POLICY REPORT  
DEVELOPMENT AND BUILDING

Report Date: September 22, 2009  
Contact: Michelle McGuire  
Contact No.: 604.873. 7271  
RTS No.: 08246  
VanRIMS No.: 08-2000-20  
Meeting Date: October 6, 2009

SUBJECT: CD-1 Rezoning/Heritage Revitalization Agreement/Heritage Designation:  
3205-3221 West 41st Avenue and 5590 Balaclava Street

Knox United Church Site

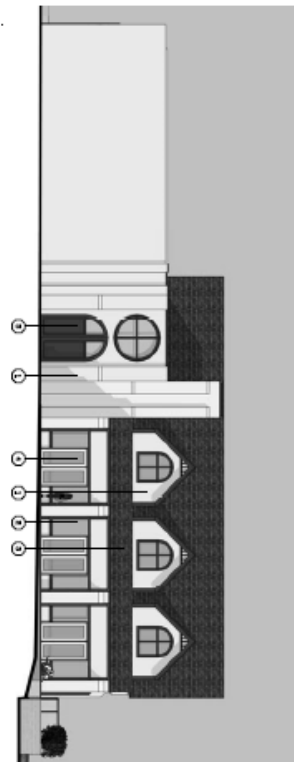
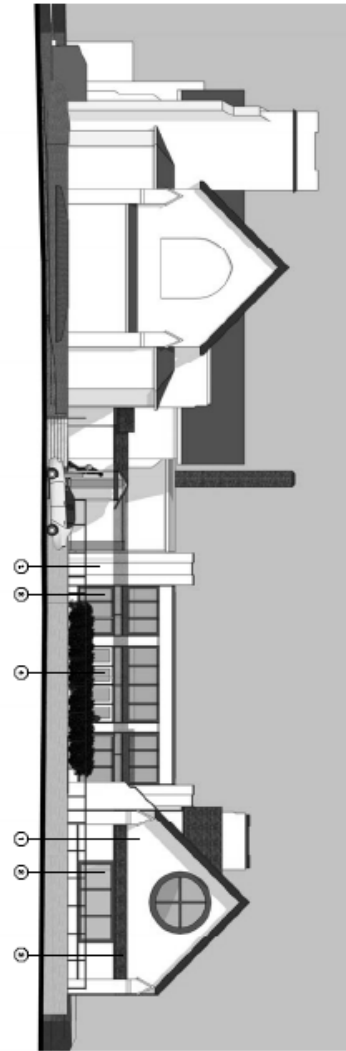
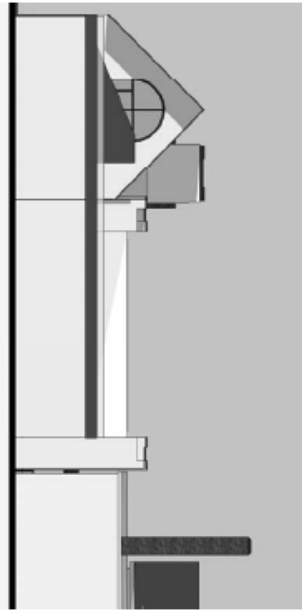
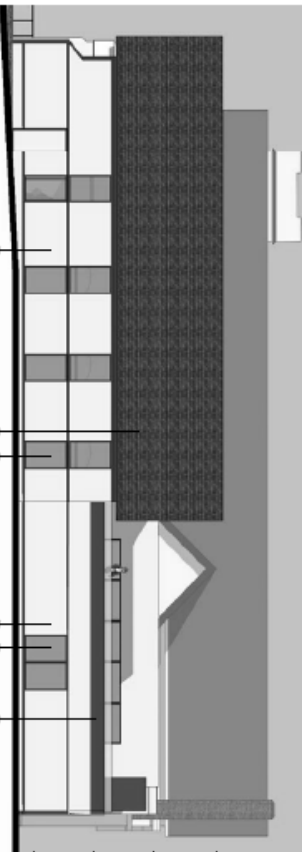
- (xi) Design development to the massing and location of the new church annex building to provide substantial improvement with regard to shadowing, privacy and visual impact on the neighbouring property to the north;

Note to Applicant: The two storey meeting space should be relocated and/ or the roof redesigned to minimize shadowing impact. Impact of the rooftop outdoor play area in the north east corner should also be minimized by pulling the building as far back as possible from the north property line as well as by employing planters or other screening which are not visually intrusive.

- (xvi) Design development to provide increased separation between the new church annex building from the existing Knox United Church;
